**PAWNEE HEALTH CENTER**  
**PAWNEE, OKLAHOMA**

**POST OCCUPANCY EVALUATION**

Office of Environmental Health and Engineering

January 2008

E-11 Emergency Generator

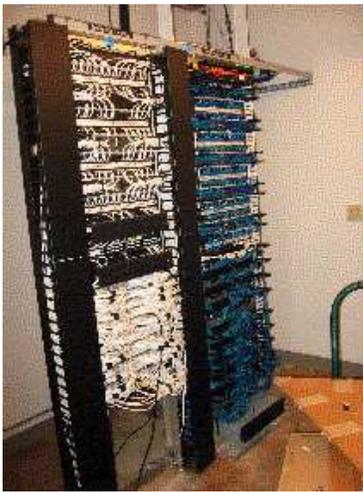
However, no documentation was found regarding engineering calculations or the criteria applied to show that the rating of the existing generator matches or exceeds the total load of the essential emergency electrical system of the new HCC. This is a requirement of NFPA 99, 4.4.1.1.9

1. Comply with NFPA 99, 4.4.1.1.9, NFPA 110.
2. Provide UPS to all Departments that use medical equipment, instruments and computers that require emergency power services in less than 10 seconds.
3. Provide light and power outlet to generator as required by NFPA 99.
